# 1997 - 2002 Corvette: Service Bulletin: SMU - Revised Side Cover and Gasket Replacement (RH)/Differential Carrier Cover and Seal Replacement

**Number:** 02-04-20-003

**Subject:** SMU - Revised Side Cover and Gasket Replacement (RH)/Differential Carrier Cover and Seal Replacement - Right

**Model Year:** 1997-2002 Chevrolet Corvette

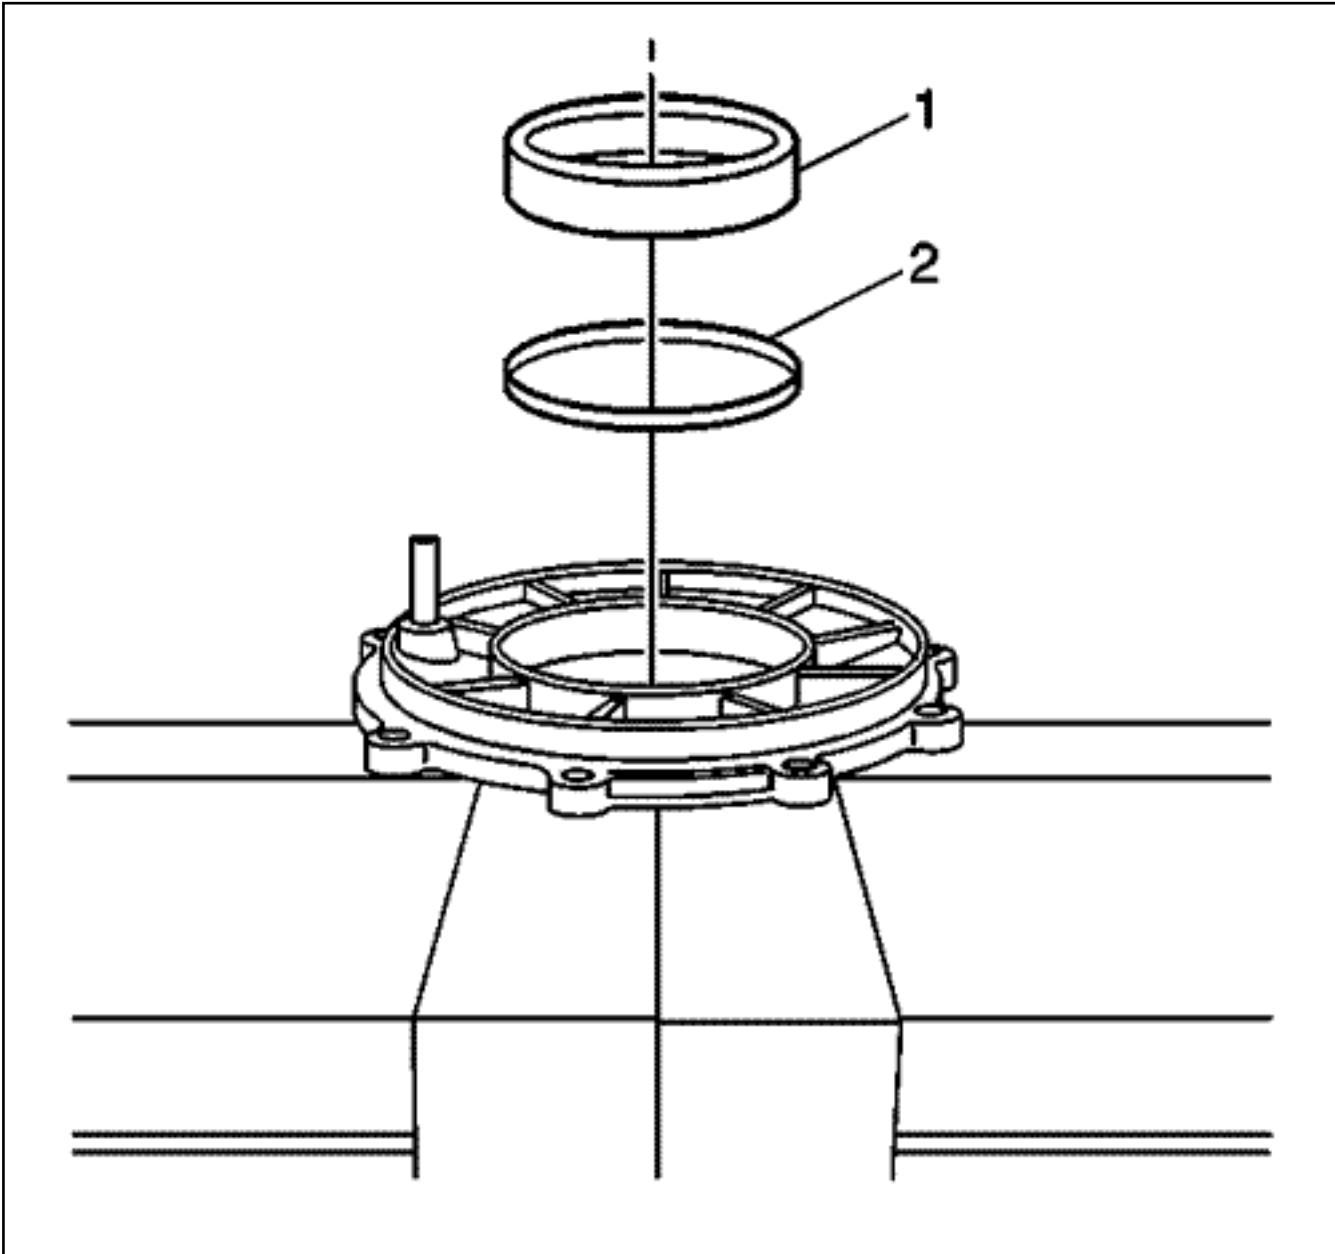
## **Important**

**Whenever service requires the replacement of the right side differential cover, the covers MUST be measured and the right side shim pack adjusted to compensate for machining tolerances between the two components. Failure to perform this measurement procedure may result in improper differential bearing preload.**

13. Use a caliper (2), a straight edge (1), and J 42168-16 (3) in order to measure the NEW differential cover bore dimension. Record the measurement as value A.
14. Use a caliper (2), a straight edge (1), and J 42168-16 (3) in order to measure the old differential cover bore dimension. Record the measurement as value B.
15. Subtract value B from value A. If the computation is a positive value, add shims equal to the value, to the existing shim pack. If the computation is a negative value, subtract shims equal to the value, from the existing shim pack.
